JL SWEATER LIMITED-EXTENDED BUILDING

5th September 2021

Buildings Information

Width and height of Building

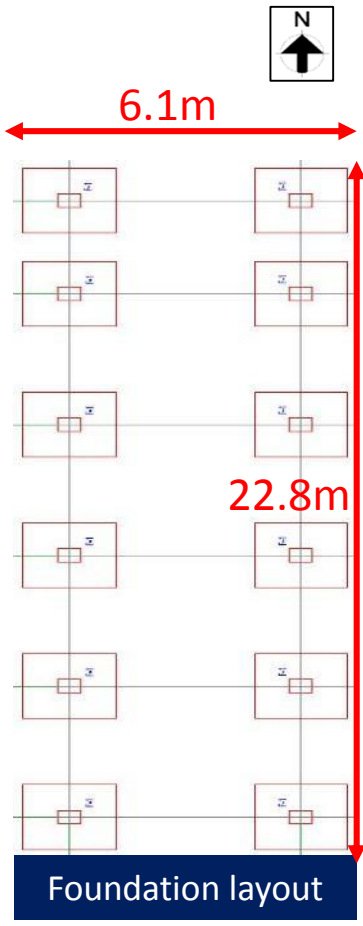
Overturning capacity of building to be checked

Pin connection considered at support

The length and width of structure are 22.8m and 6.1 m respectively. The height of the building is 12.8 m. The building has cantilever along the length. Hinge support for foundation to column joint is considered for analysis. As the building is single bay structure, height is more and have cantilever in critical direction, the factory engineer should check the sway & over-turning capacity of the building against the lateral loadings and revise the foundation adequacy accordingly.

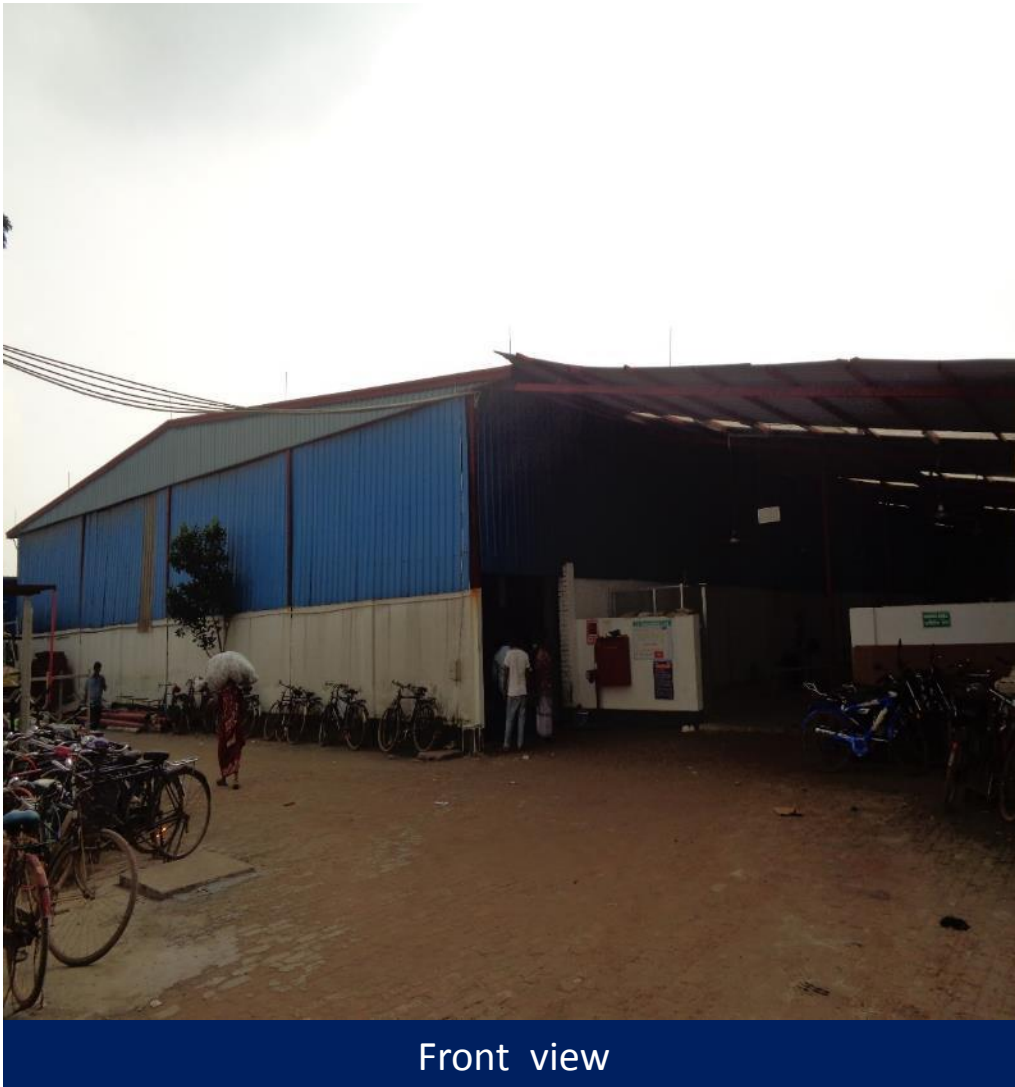
Sign of water stagnant on roof slab

Water stagnant on roof slab

Sign of water stagnant was found on roof slab. Factory is required to provide necessary slope and improve drainage system to prevent water stagnant.
